Development Assessment

DA 2024/1562 - 5 Lauderdale Avenue, Fairlight

VISUAL IMPACT ASSESSMENT

OBJECTION to Development Application DA2024/1562 at DP 24923, No.5, Lauderdale Avenue, Fairlight.

VIEWPOINT 01

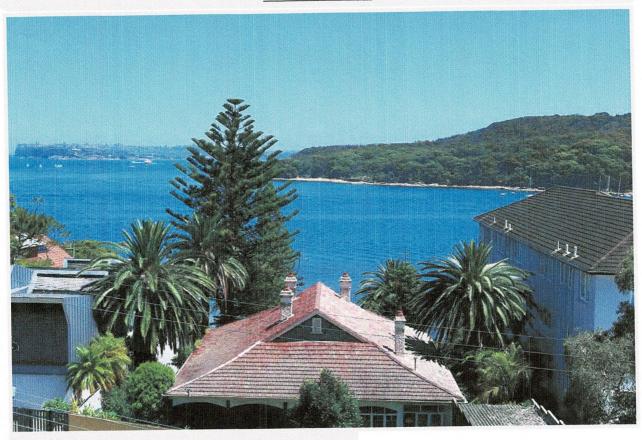
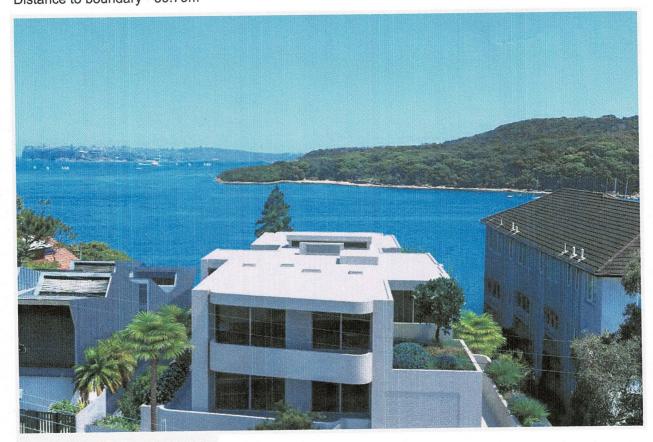
- Visual impact Amount of new development visible in view 83%
- Visual impact ratio view loss (including buildings): sky view loss: 100%: 0%
- Existing Visual Assessment Scale no: 12/15 & Visual Impact Assessment Scale no: 10/15

The visual impact of the proposal will result in loss of a large area of the water element of North Harbour and a reduction in the quality of elements in the view, from natural, landscaped elements to a hard bulk and scale of the flat rooftop of the new proposal.

- · Value of view: High
- · View location: Outdoor Living Area Primary living area
- Extent of impact: Moderate-to-Severe

Reasonableness of proposal: The non-compliant upper-level mass of the proposal sits directly in front of this viewpoint, removing visual access to a significant area of the water view. As a result of the unreasonable proposal, a more skilful design should be submitted to reduce the visual impact and adhere to the Council's guidelines for view-sharing.
